Director's Report

Project Name: Edendale

Description: Final Site Plan Approval

RE: Edendale Crossing- Final Site Plan Review – 1st Review

SCALE	N/A
SHEET	11 OF 19
KE	2025.010

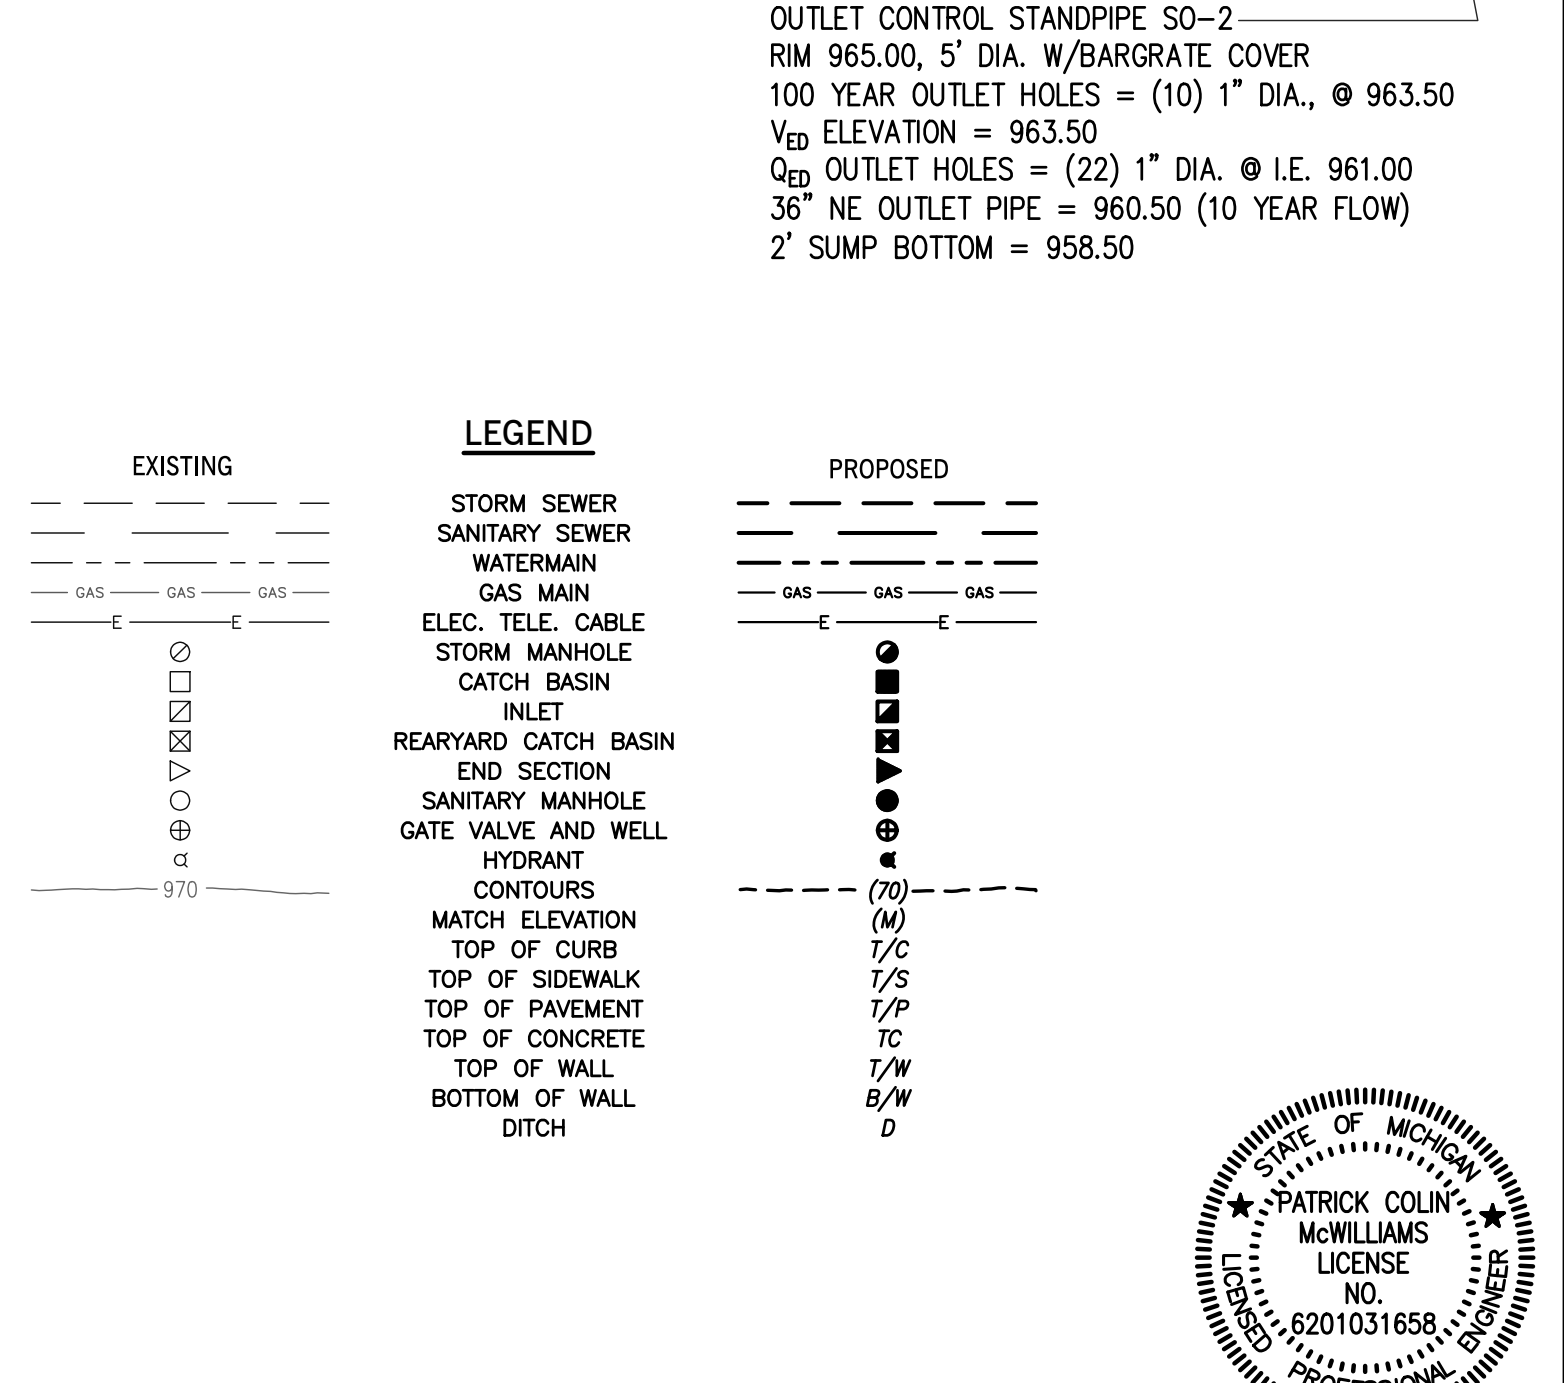
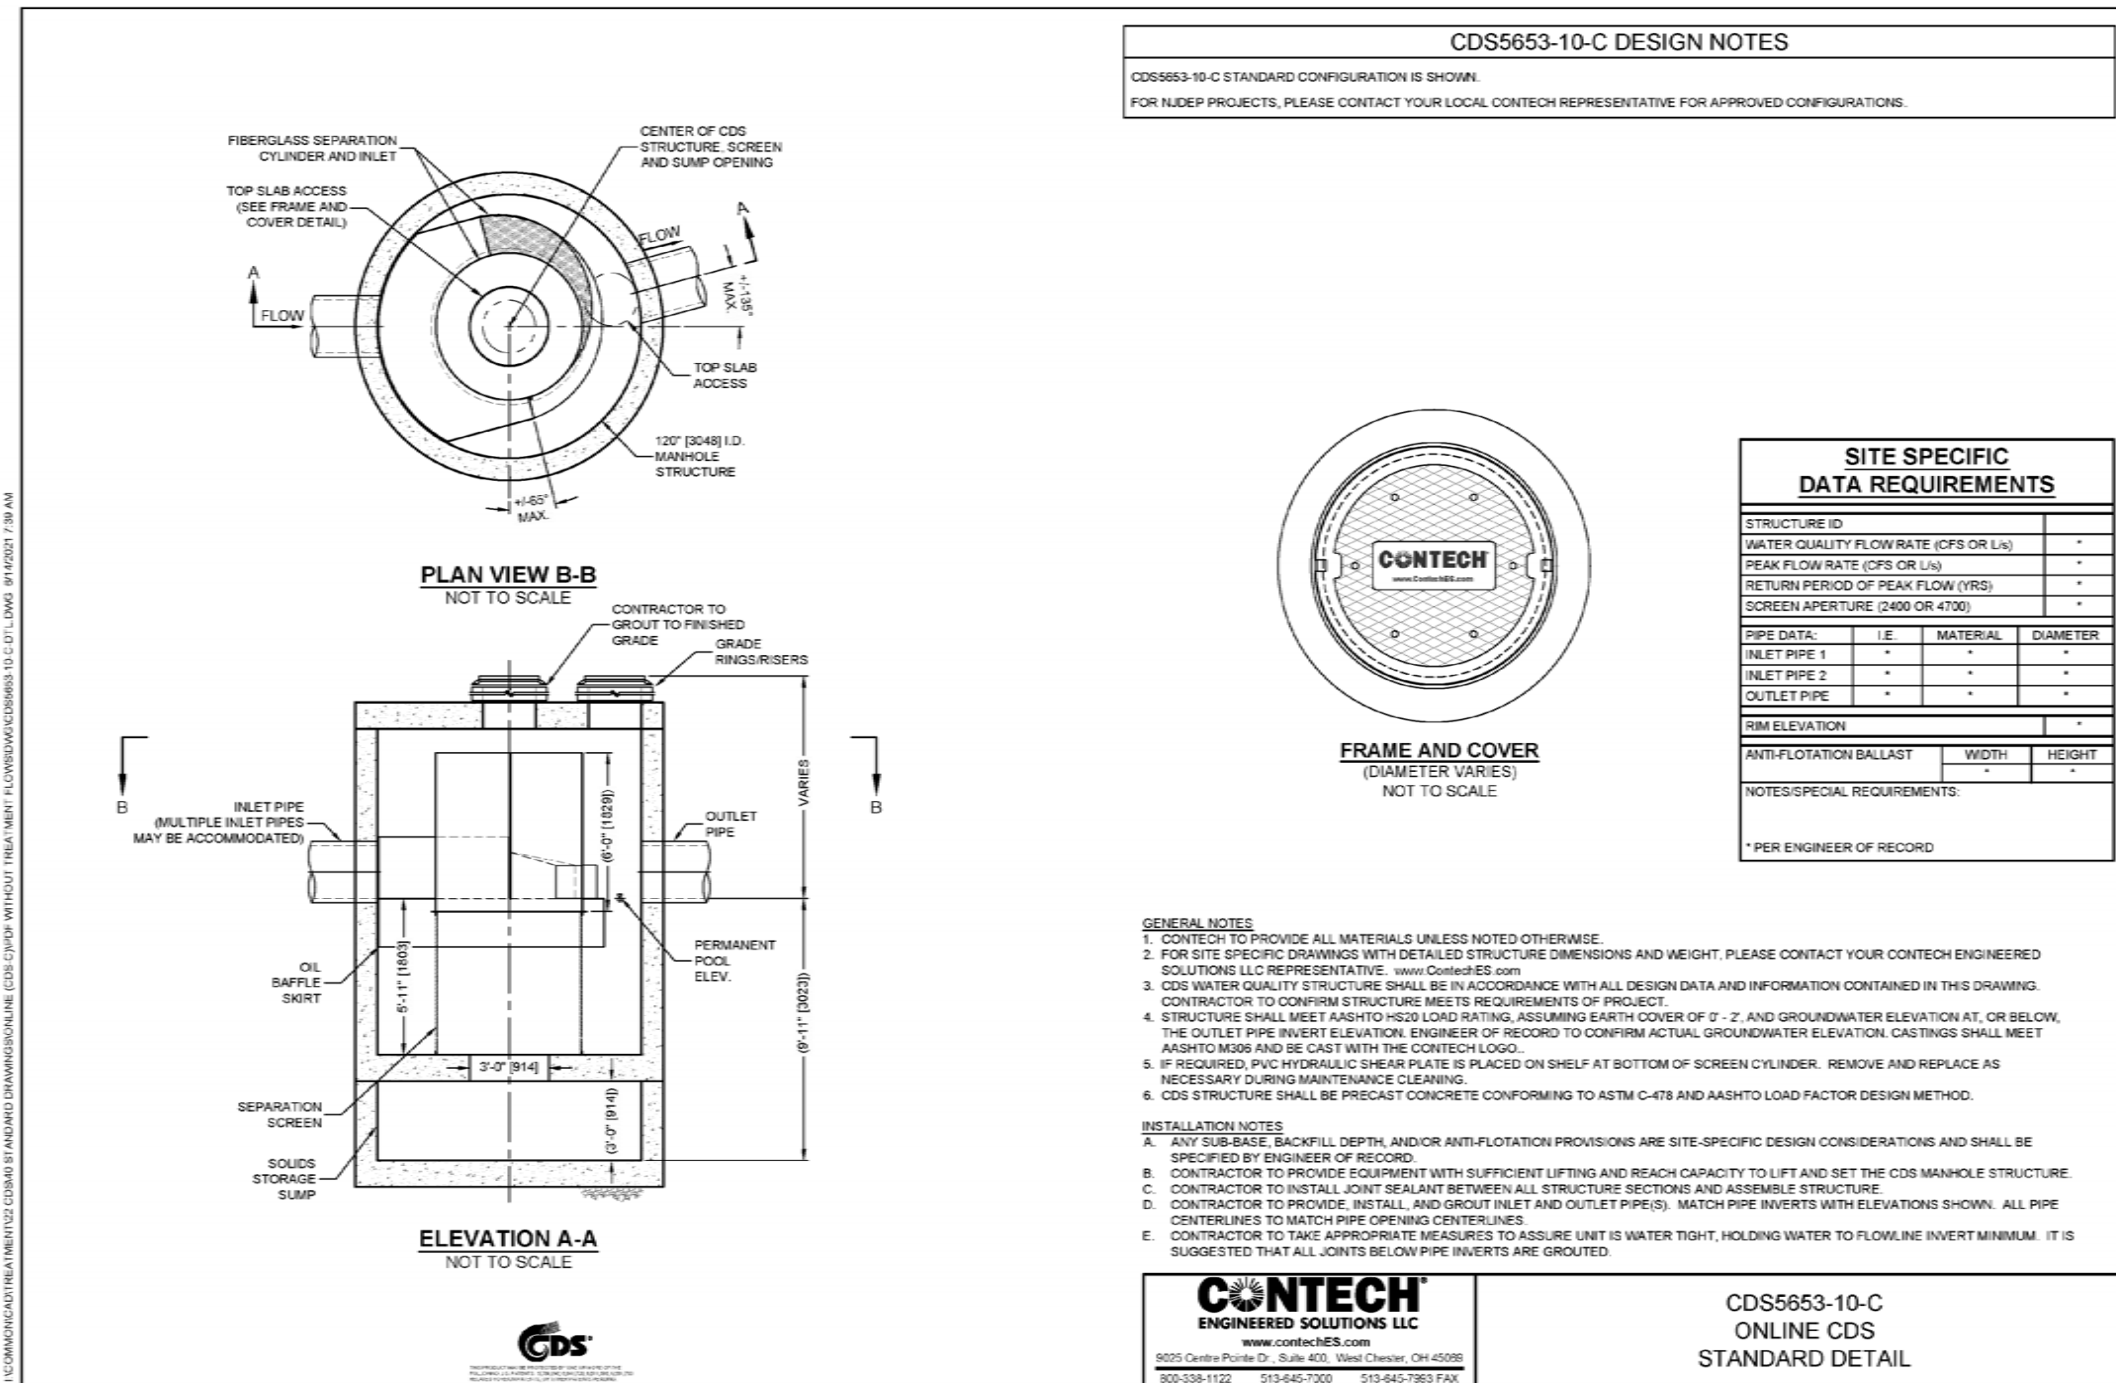
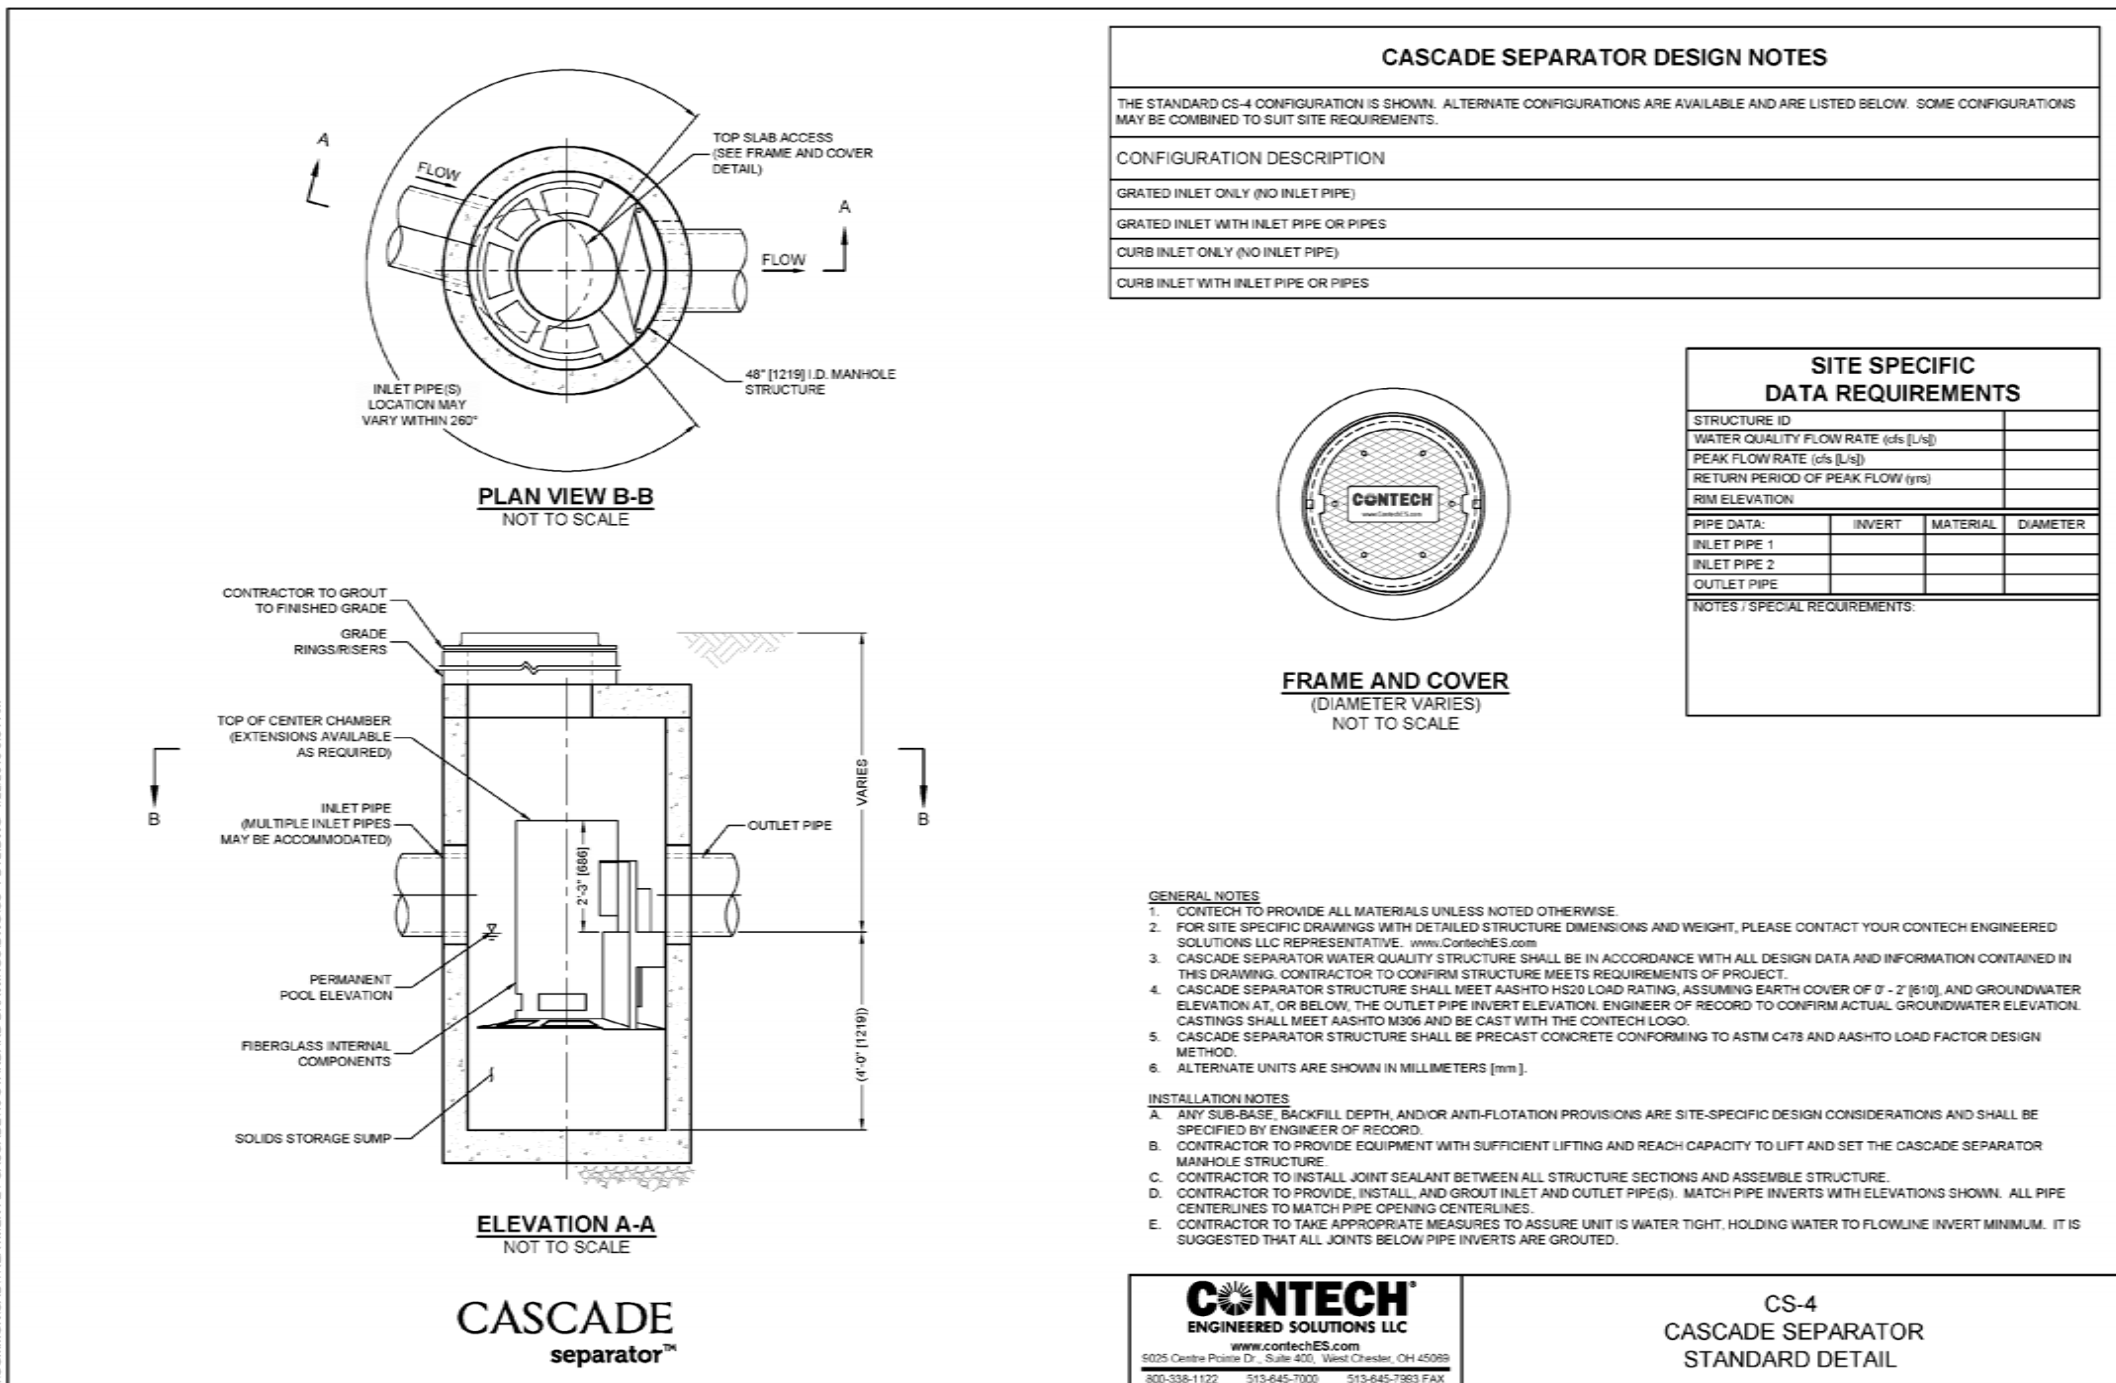
1. Sheet 11- Please see marked up calculations for revisions that shall be required.
2. We note that the location of the proposed sanitary pump station has changed from the Township Board approved Preliminary Site Plan. We consider the revised orientation to be an improvement compared to what was previously indicated so we do not take issue with this item but wanted to note the change.

Shown on Sheet 3 as 3.20 acres

In addition, Sheet reference note on Sheet 3 references Sheet 16; it should be Sheet 11.

Stormwater calculations:	100-year basin calculations have been revised and are provided on Sheet 11
